Access Compliance Report

Public Rights-of-Way

Intersection ID: 18705	Main Street: HAVEL_CT	Cross Street: KIRKPATRICK_RD	Location:	N
ADA ID: 3A87D4E79658	Ramp Type: BlendTrans1	Initial Pass/Fail: Pass	Overall Compliance: No	Severity Score: 10

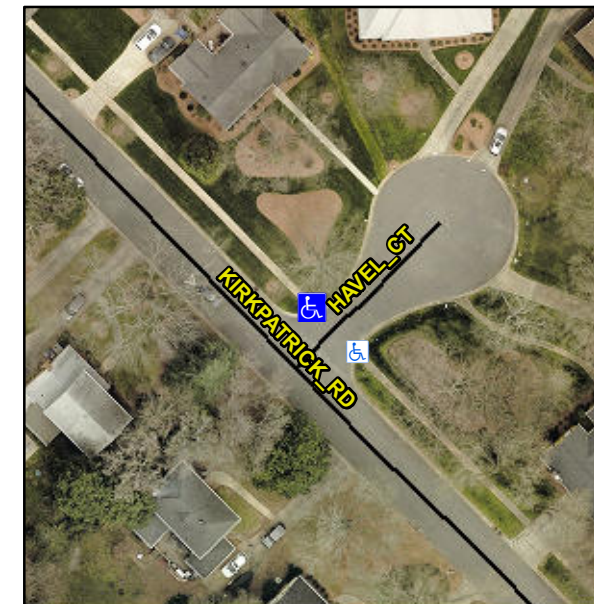
Remove & Replace Curb Ramp With Two New Directional Ramps or Equivalent.

Not Found, R305

N/A	Ramp inside XWalk1?	N/A	N/A	Ramp inside XWalk2?	N/A
	Road Slope (%)	0.1		Clear Space?	Yes
	Road X Slope (%)	1.0	N/A	Clear Space to XWalk (in)	N/A
Yes	Any Obstructions?	No	Yes	Storm Grate/Utility Hazard?	No
	Obstruction Type			Storm Grate/Utility Type	
		N/A			N/A
			Yes	Surface Condition? (G/P)	Good
			No	Curb Slope (%)	29.2
